Extinction ratio in DR links (comment 199)

Piers Dawe

NVIDIA

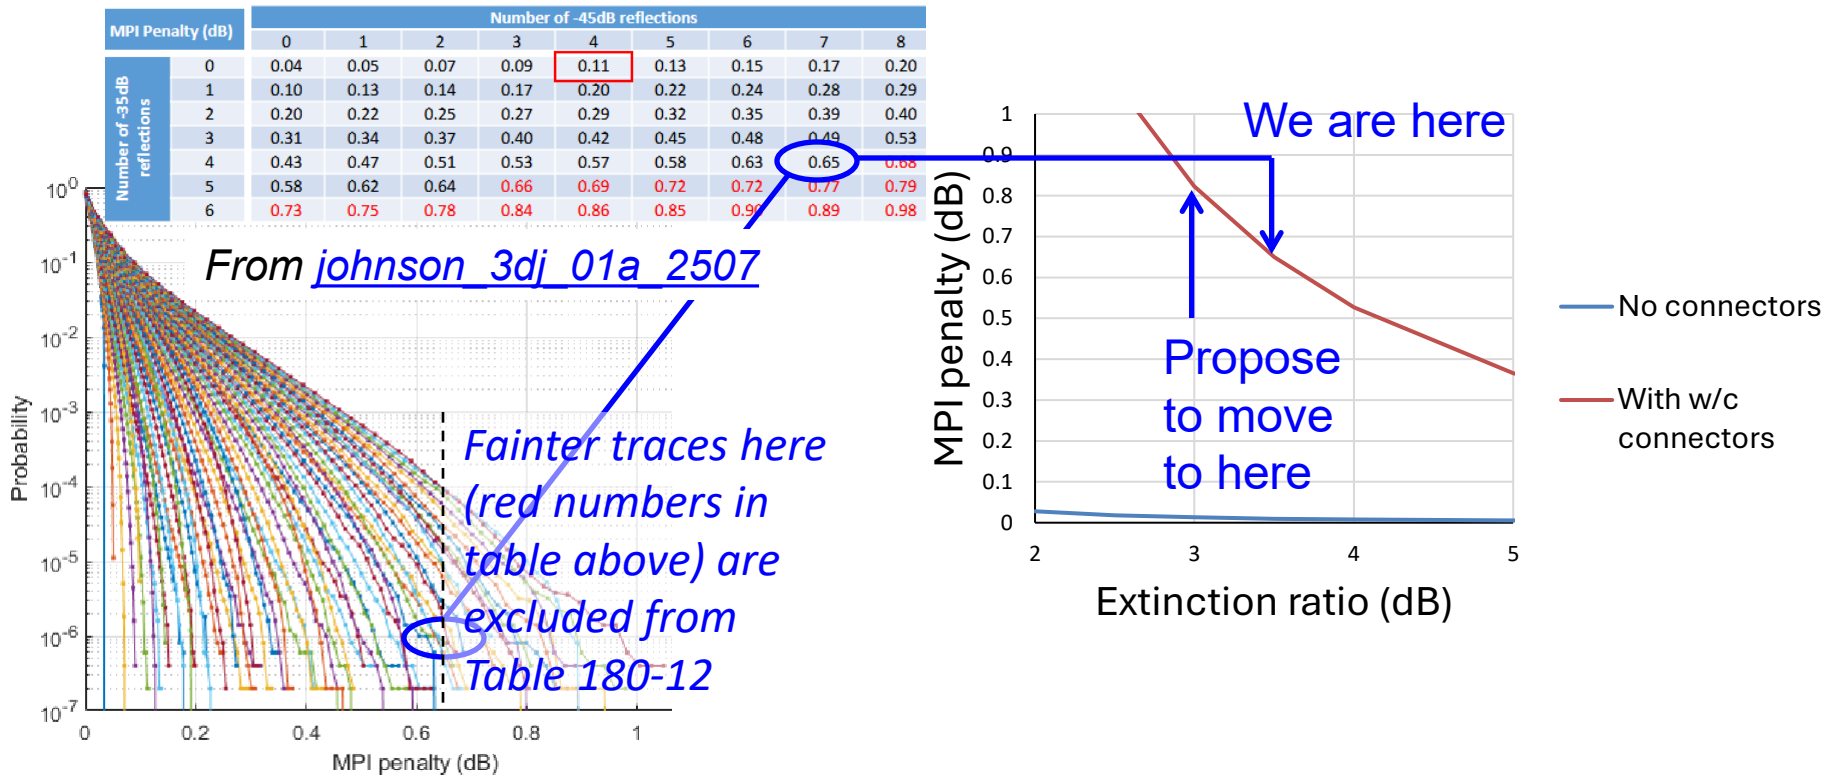
- The 0.1 dB mentioned (actually 0.11 dB per [johnson 3dj 01a 2507](#)) applies to a cell where 3 dB loss is allowed
 - This is barely changed at 3 dB extinction ratio: it rounds to 0.1 dB
- The worst allowed cell at the bottom of the table represents an MPI penalty of 0.65 dB. "We are here" on next slide

Some scope for improvement

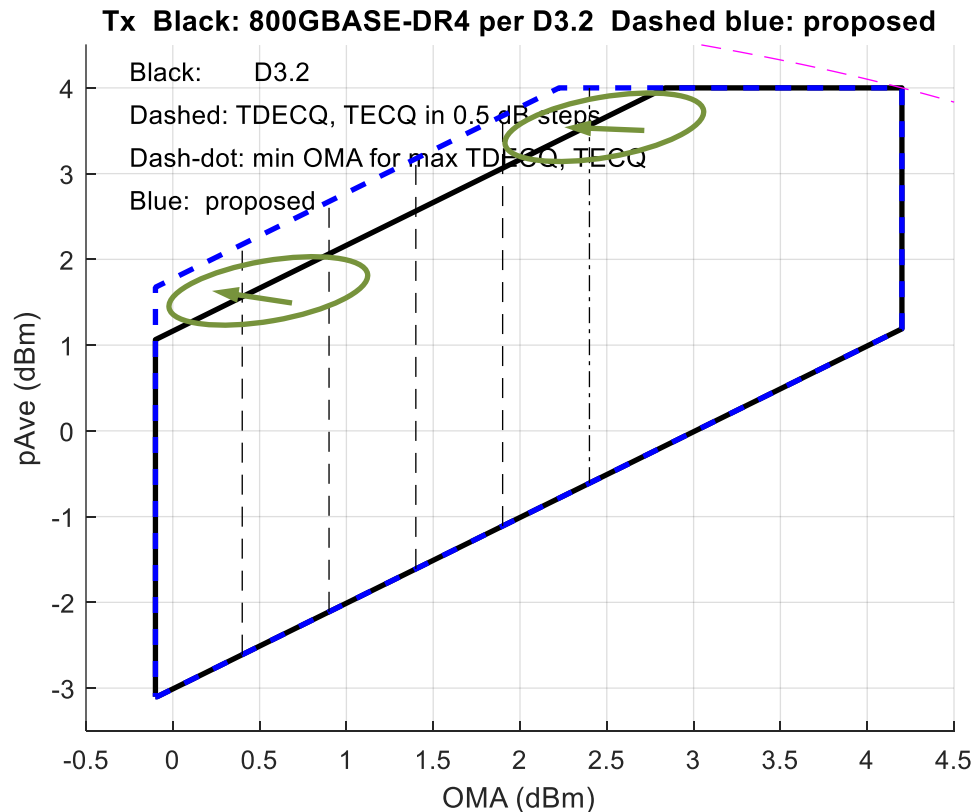
- We can reduce the limit from 3.5 dB to 3 dB for a cost of <0.2 dB
- This is a very good trade for the transmitter

Average power vs. OMA map

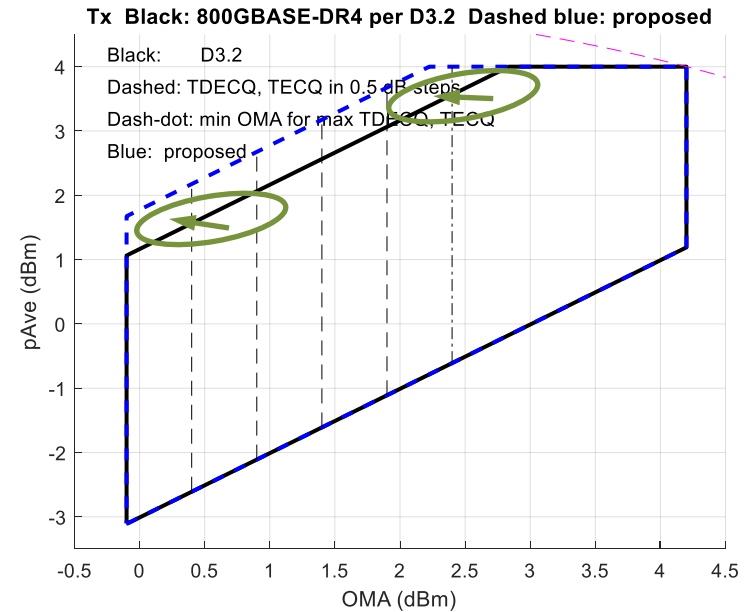
- Changing the min extinction ratio from 3.5 dB (black) to 3 dB (blue).
Dashed and dash-dotted ECQ lines don't change
- Example areas of interest in green
- Thin magenta line is locus of constant power in 3s, showing that receiver is not exposed to more power in 3s by the change

- Revise Figure 180–4, Receiver sensitivity ($\text{OMA}_{\text{outer}}$), each lane (max)
 - and
- Figure 180–5, Transmitter $\text{OMA}_{\text{outer}}$ each lane versus max(TECQ, TDECQ) and receiver sensitivity ($\text{OMA}_{\text{outer}}$) each lane versus TECQ
- Rx lines move down by 0.2 dB
- Fig 180–3 does not change

Why not like 100GBASE-DR and dawe_3dj_01_2607 option 1?

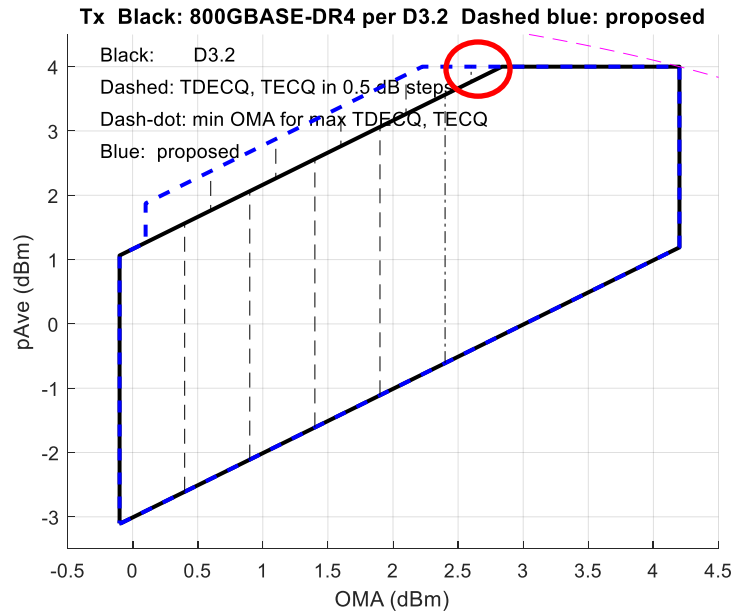
- Left: previous option 1
- (Could be made to work with increased pAve)

Right: previous option 2 = this proposal

This proposal provides better relief for the transmitter with minimal impact on the receiver

Both proposals have no impact on the cabling
